CITY OF LOS ANGELES
INTER-DEPARTMENTAL CORRESPONDENCE

Subject: **VESTING TENTATIVE TRACT MAP NO. 72370-CN**

8150 W Sunset Bl
DOT Case No. CEN 13-41328

Subject: **TRAFFIC IMPACT ASSESSMENT FOR A MIXED-USE DEVELOPMENT
LOCATED AT 8150 WEST SUNSET BOULEVARD (CPC-2013-2551-CUB-
ZV-DB-SPR/ENV-2013-2552-EIR)**

FIGURE 3(a)

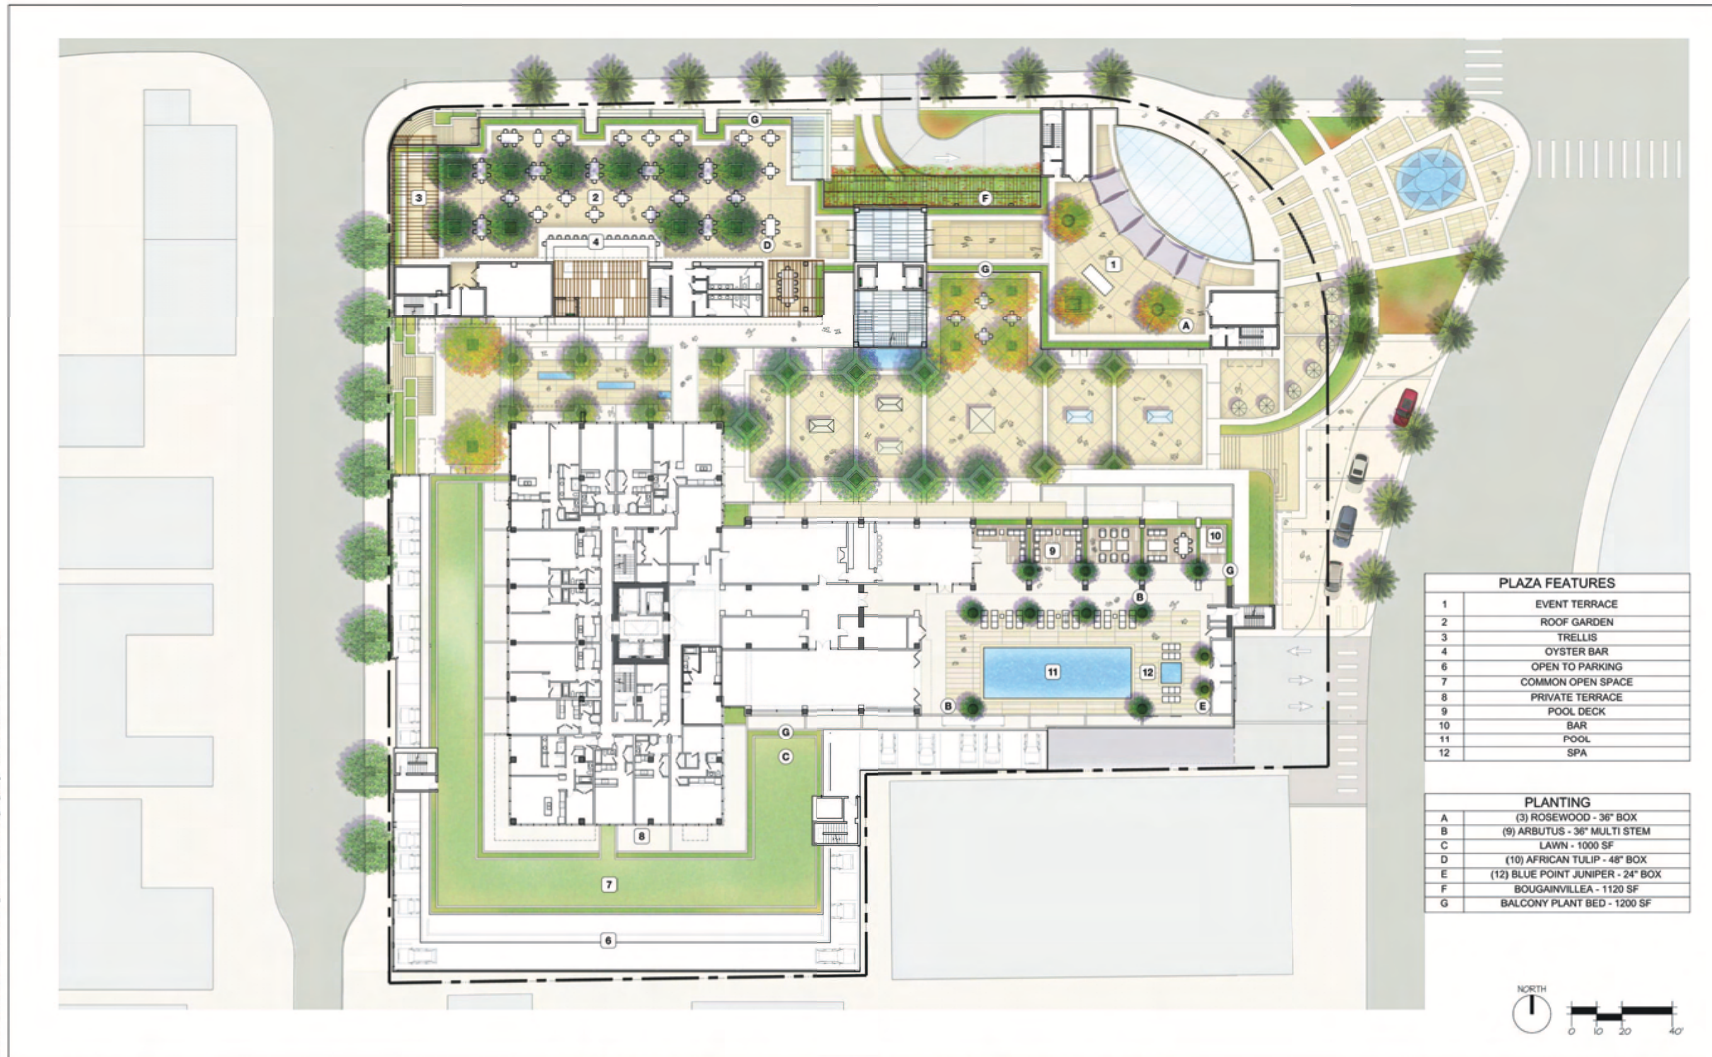
The proposed project will demolish the existing active shopping center and construct a new mixed-use development with 249 residential apartments (including 28 affordable units) and 111,339 square feet of commercial space at 8150 West Sunset Boulevard (see **Attachment 2**). The commercial space would include 51,150 square feet of retail uses, a 24,811 square foot supermarket, 22,189 square feet of quality restaurant space, a 5,094 square foot walk-in bank, and 8,095 square feet of health and fitness uses (dance studio, yoga studio, etc.). The existing 80,000 square foot shopping center

includes 14,647 square feet of typical retail uses, a 20,172 square foot walk-in bank, 11,646 square feet of restaurant and fast food uses, a 2,360 square foot dental office, a 3,550 square foot martial arts studio, and a 27,625 square foot art storage facility. The project would provide 849 automobile parking spaces and 985 bicycle spaces in a multi-level (subterranean and above-grade) parking structure. The project proposes to provide access points at approximately the existing three driveways. The project is expected to be completed by 2018.

FIGURE 8
 CONCEPTUAL IMPROVEMENTS
 TO SUNSET BOULEVARD AND CRESCENT HEIGHTS BOULEVARD

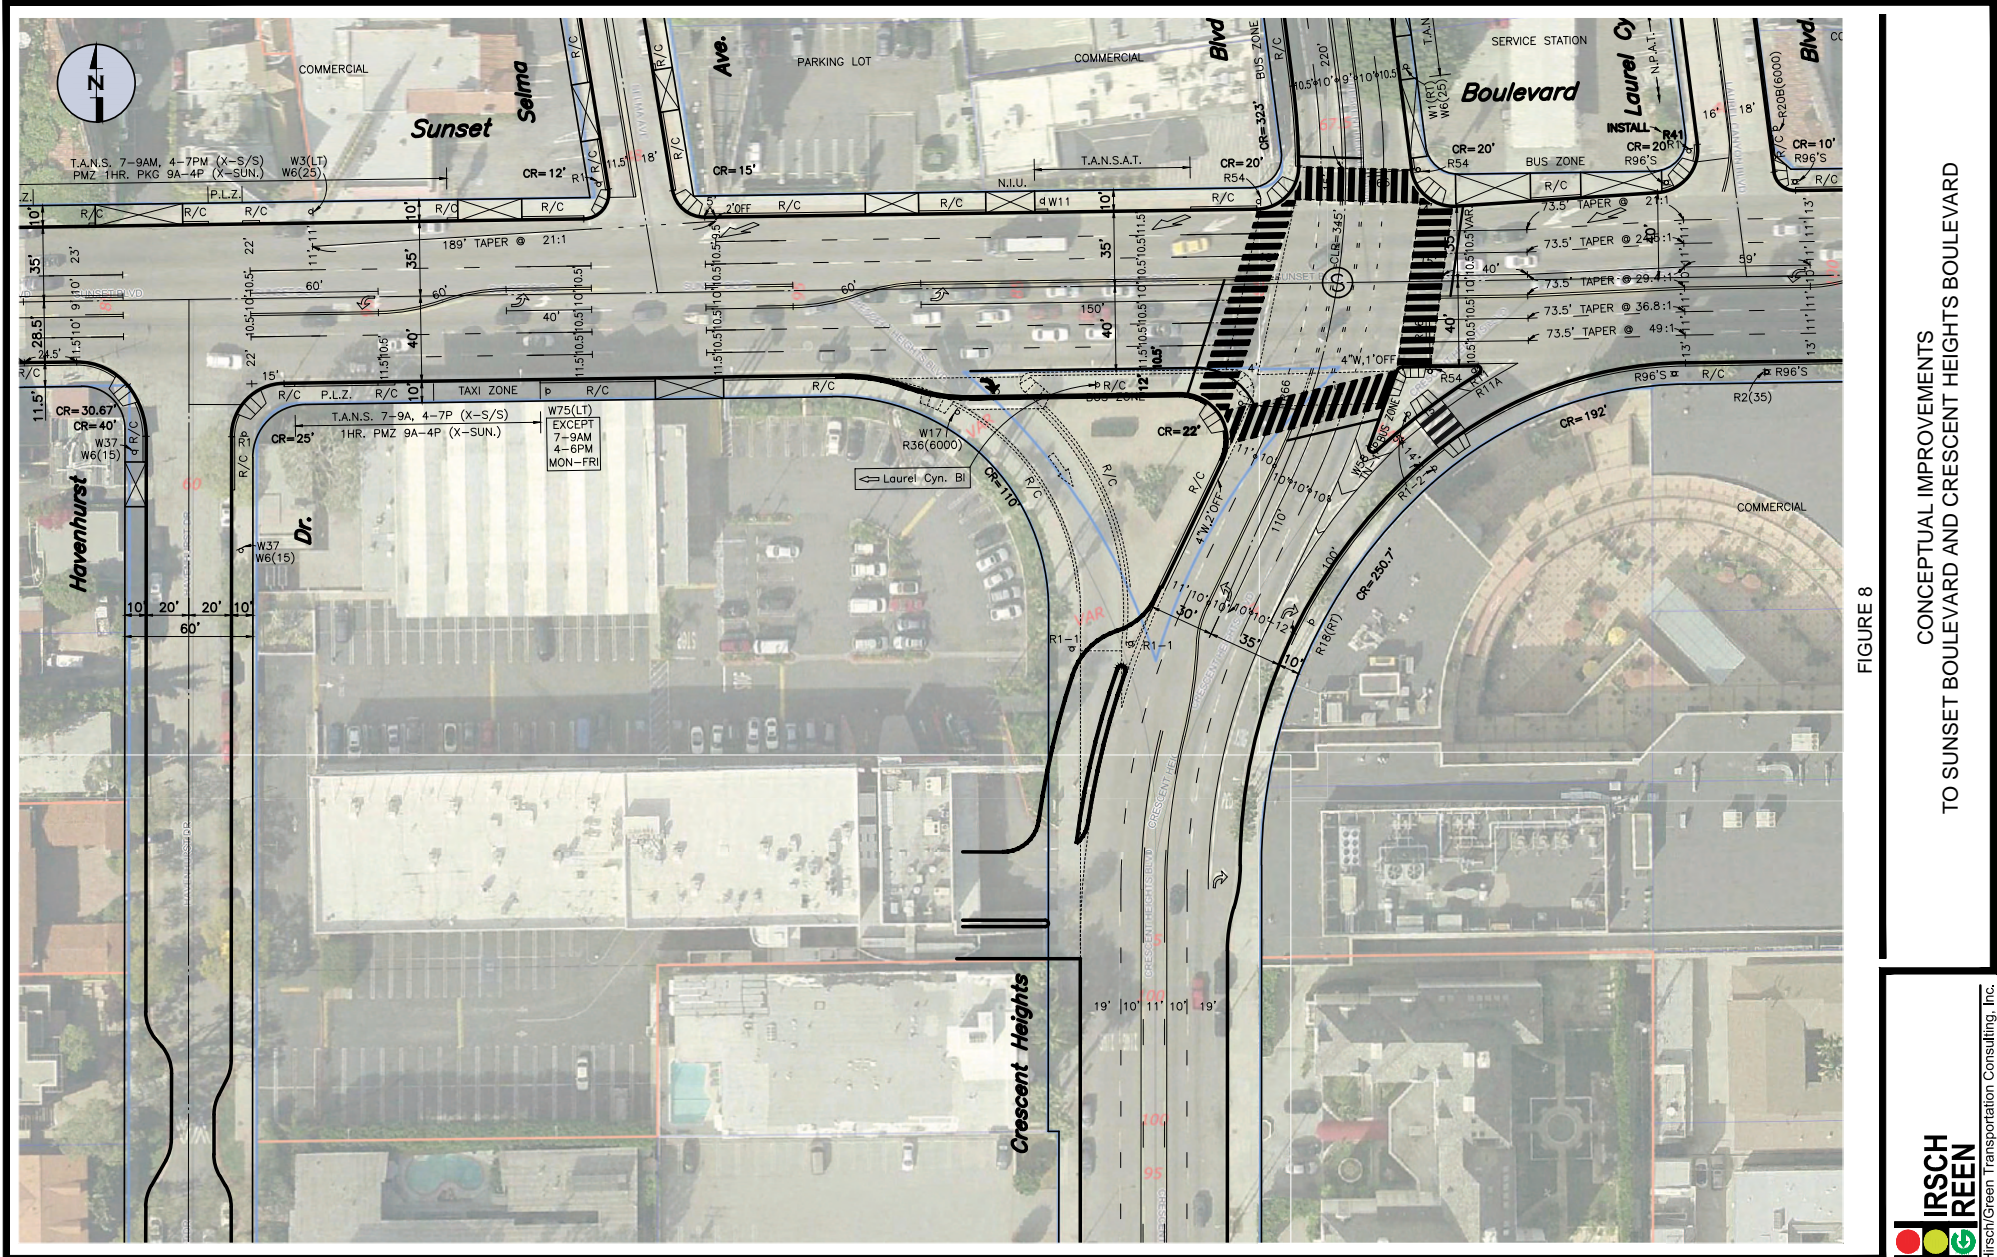
To enhance and activate the pedestrian environment adjacent to the project, the project proposes to reconfigure the southwest quadrant of the intersection of **Sunset Boulevard and Crescent Heights Boulevard**. The improvement would remove the current sweeping eastbound right-turn lane on Sunset Boulevard that is stop-controlled before merging with southbound Crescent Heights Boulevard, and install a typical exclusive right-turn lane at the intersection. The unused "triangle" section would then be reconfigured to provide a new public "plaza" area adjacent to the northeast corner of the project site as illustrated in **Attachment 4**.

To accommodate the exclusive eastbound right-turn lane, the south side of Sunset Boulevard would be widened and the west side of Crescent Heights Boulevard between Sunset Boulevard and the project's driveway would be reconstructed. Conceptually, this improvement is acceptable to DOT; however, to ensure optimal efficiency and safety of the intersection's operations for all modes, the existing bus stop on the eastbound approach should be relocated from the near-side and the traffic signal may need to be upgraded to install northbound left-turn phasing and concurrent eastbound right-turn phasing (subject to review by DOT's Hollywood/Wilshire District Office). These design issues should be discussed with DOT prior to the commencement of the engineering plans for this improvement.
